Development of Cricket Ground at Mills Park
RFP #354-PR26-14
Addendum No. 1

The purpose of this addendum is to answer questions received during the open question and answer period to date, including questions asked at the April 15, 2026, onsite preproposal meeting. All other terms and conditions given in this Request for Proposals are in full force and effect.

GRADING PLAN

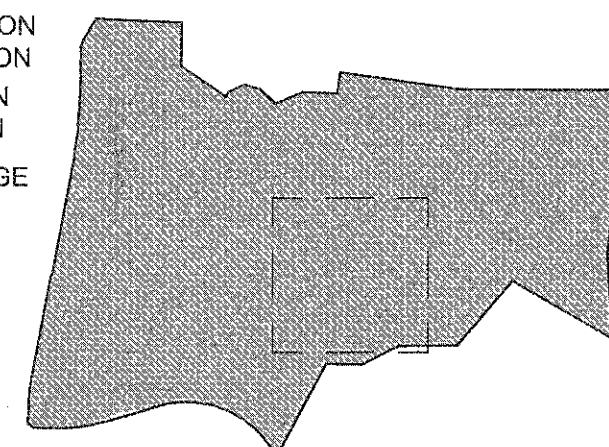
Question: Was there fill on site to create the existing field area?

Answer: Please see the attached grading plan that shows how the site was graded.
